STATE OF NORTH CAROLINA  
DEPARTMENT OF TRANSPORTATION

Subject: **Supplemental Information to Application for Nationwide Permit 23 and 33 and Riparian Buffer Certification** for the replacement of Bridge No. 108 over Lower Barton's Creek on SR 1834, Wake County. Federal Aid Project No. BRZ-1834(2), State Project No. 8.2407901, T.I.P. No. B-3704: Division 5

NCDOT submitted a Nationwide Permit 23 and 33 and Riparian Buffer Certification application dated May 20, 2004. Since the submittal of this application it was determined by NCDOT that the design of the temporary causeway in the May 20, 2004 application would not work. Changes have been made to the temporary causeway design. Revised permit drawings and revised PCN form are included in this supplemental application. No changes have been made to any other part of this project other than the temporary causeway.

PROJECT REFERENCE NO. <b>B-3704</b>	SHEET NO. <b>4</b> of 9
R/W SHEET NO.	
ROADWAY DESIGN ENGINEER	HYDRAULICS ENGINEER
<b>PRELIMINARY PLANS</b> DO NOT USE FOR CONSTRUCTION

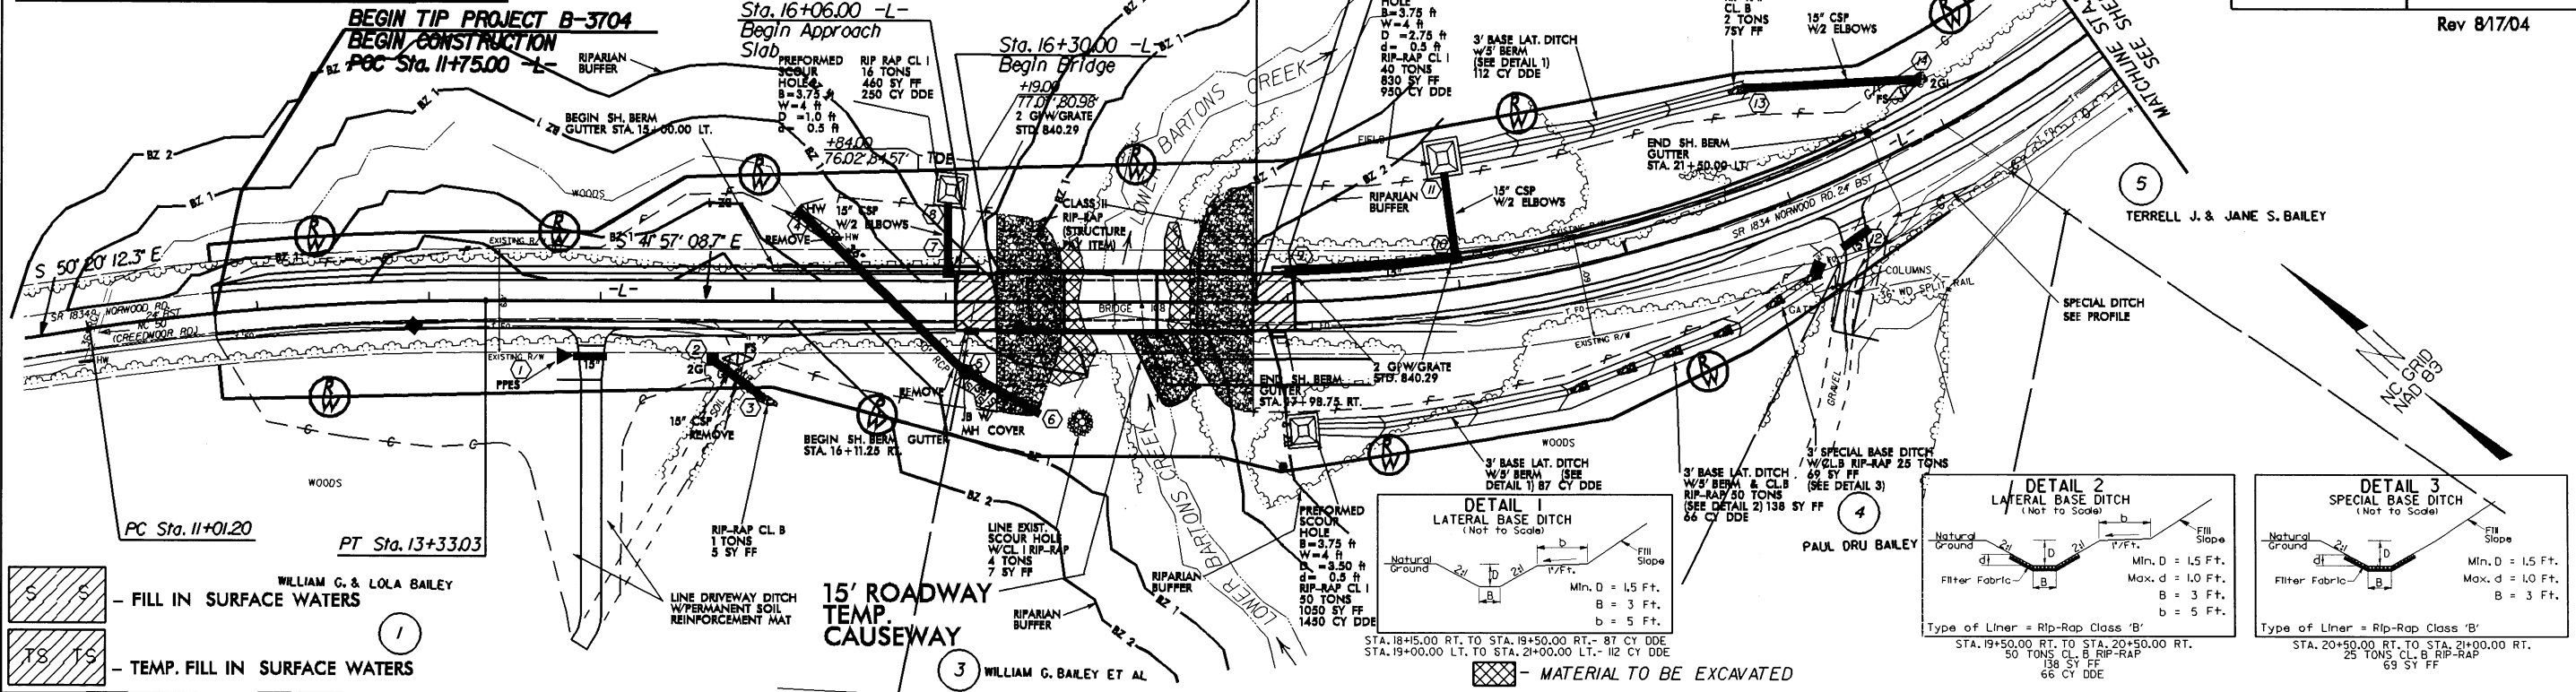
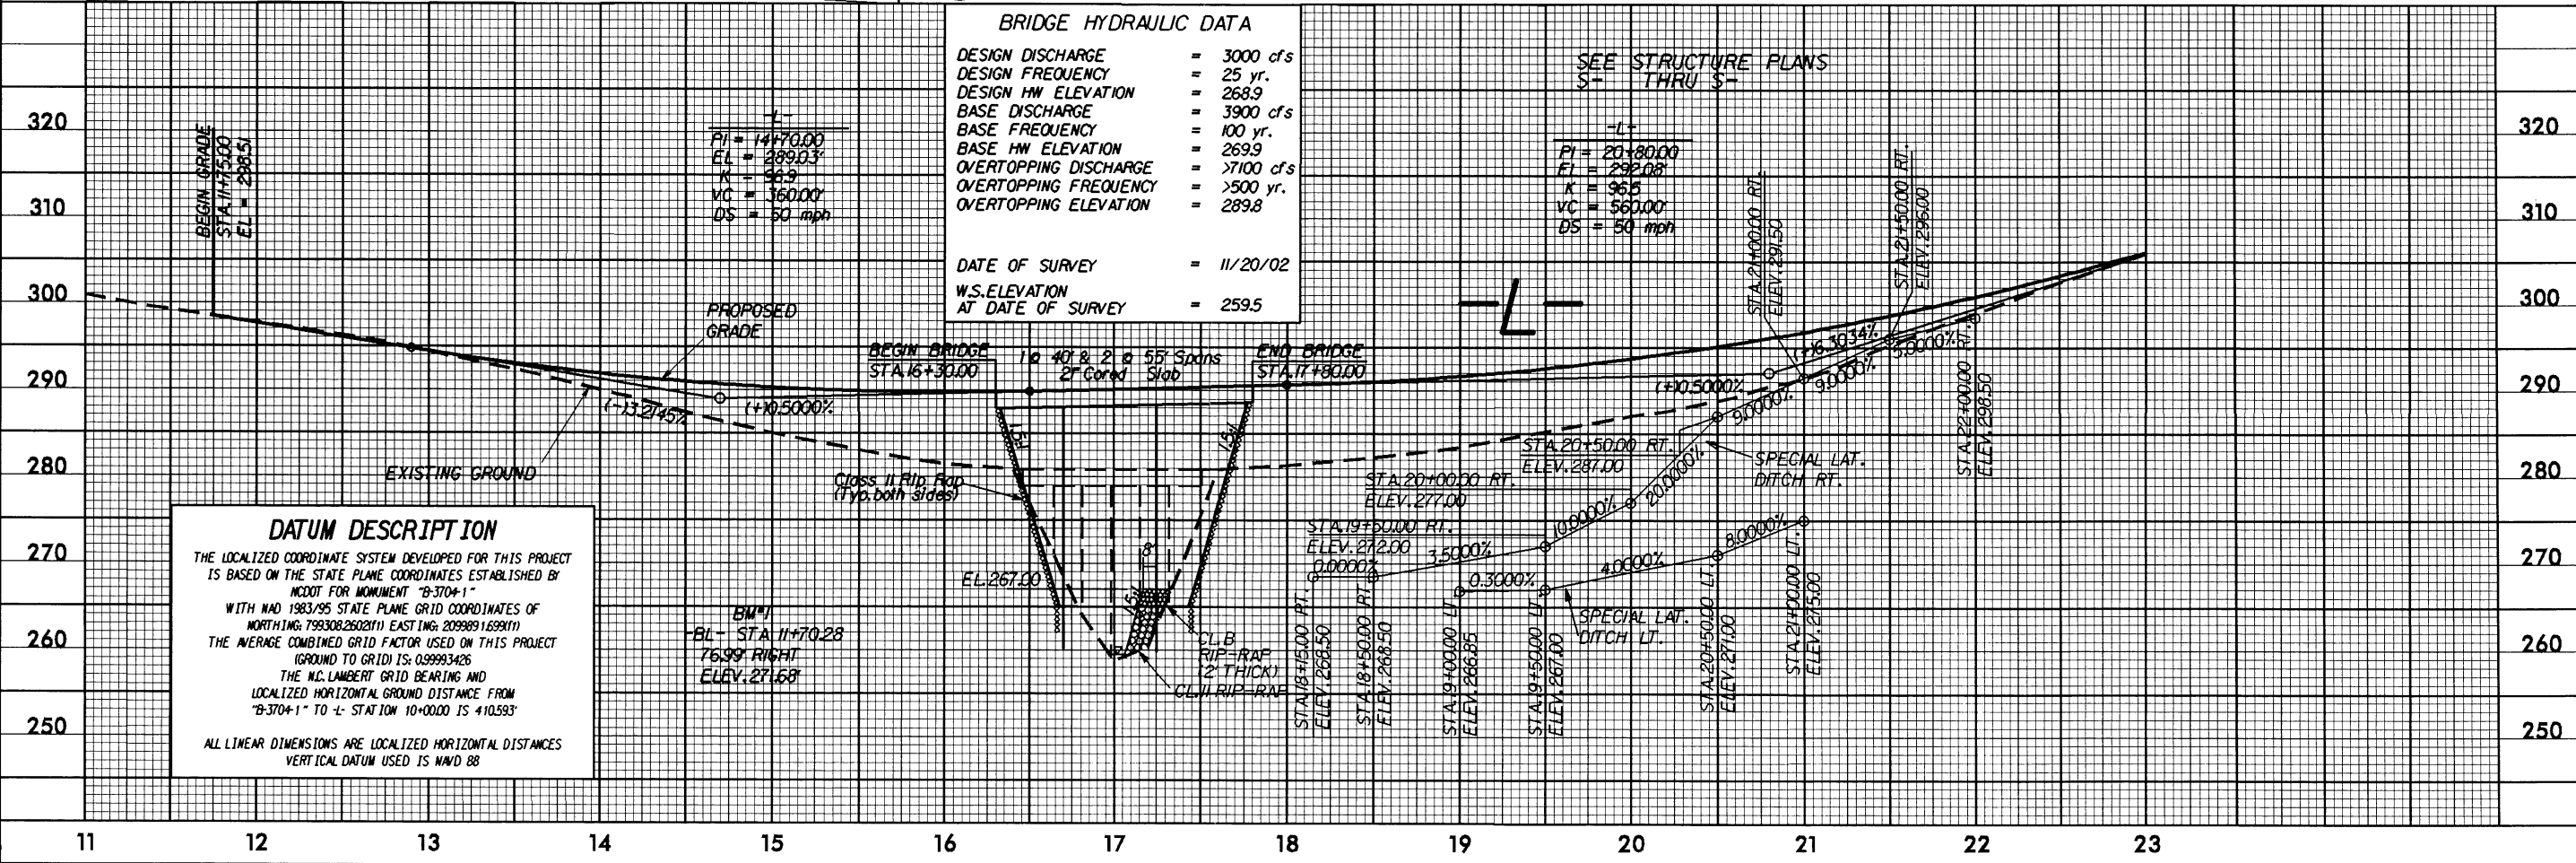
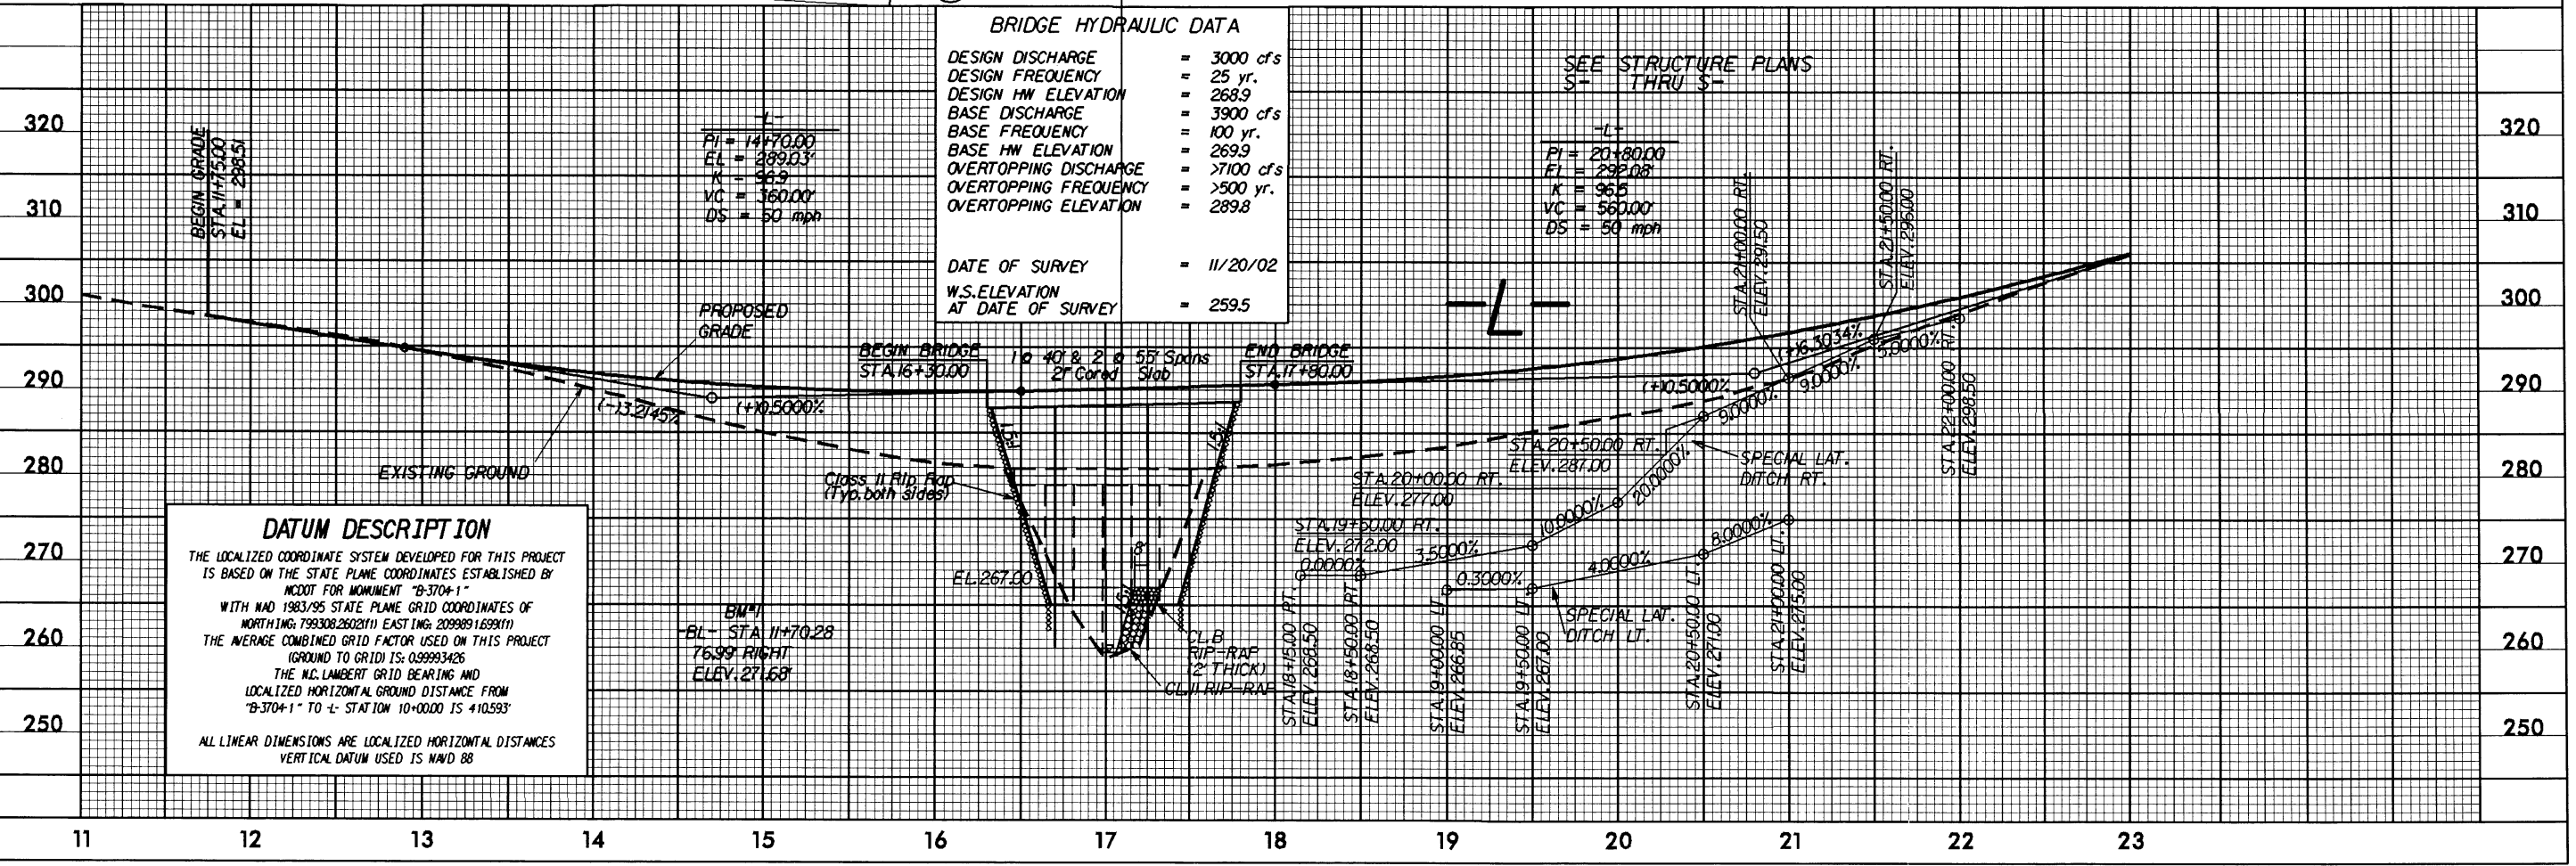
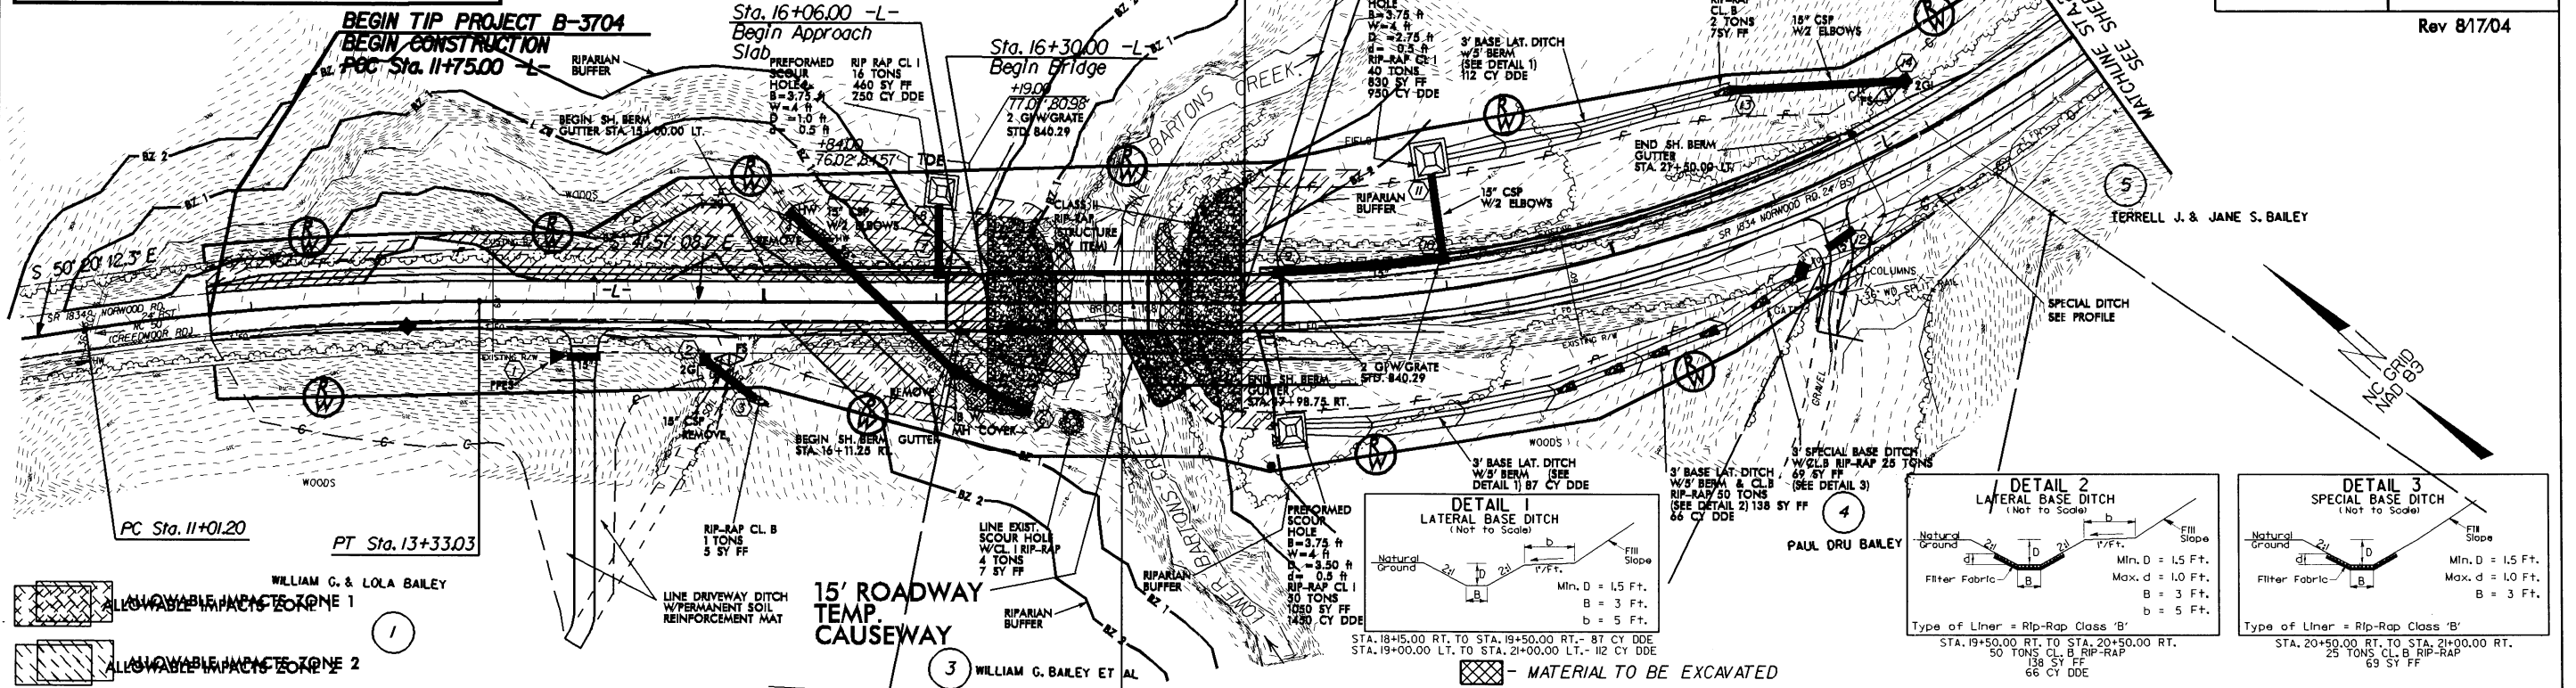
Bridge No. 108 over Lower Barton's Creek (Site 1) will be a 3-span, 150-foot cored slab bridge. This new bridge is 46 feet longer and 11 feet wider than the existing bridge. The construction of the bridge will require the use of a temporary work pad consisting of Class II and Class B riprap to provide access to the site for the construction equipment. The original design showed two causeways. The causeway on the west side of the bridge was removed from the design and now only shows one causeway on the east side. This causeway was moved further south of the existing bridge to allow for the construction of a temporary roadway causeway. The causeway is 15 feet wide with 1.5:1 slopes. The resulting temporary surface water fill will be 0.01 ac. This amount was reduced from the original application. Construction of the proposed temporary causeway is depicted in the attached drawings (Permit Drawing 3 &4).
